■LP2998：Vrefoutput

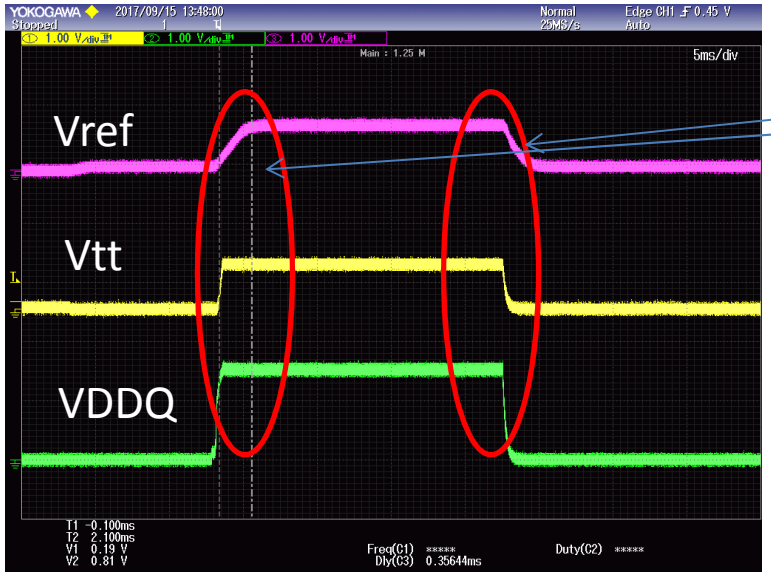
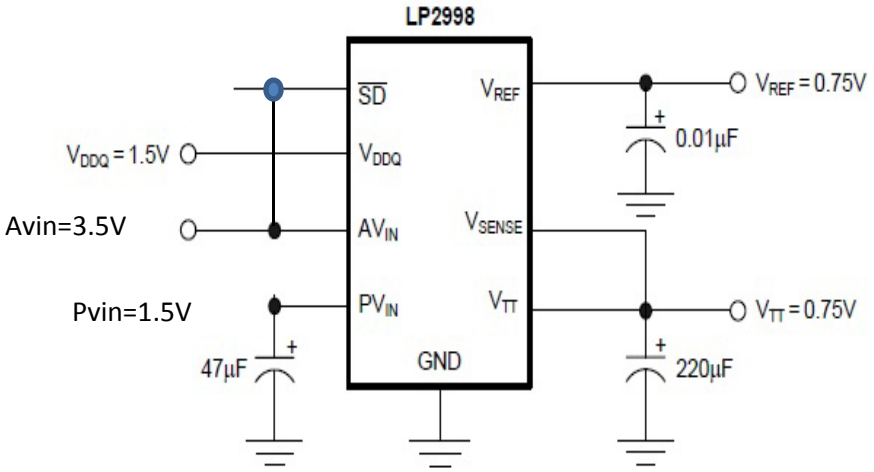
Vref:A few mS（milliseconds）delay

Sequence：AVIN＝SD=3.5V → VDDQ=PVIN=1.5V
MEM:DDR3 1 piece

Question
・Why is the rising and falling edge of Vref terminal delayed by several mS?
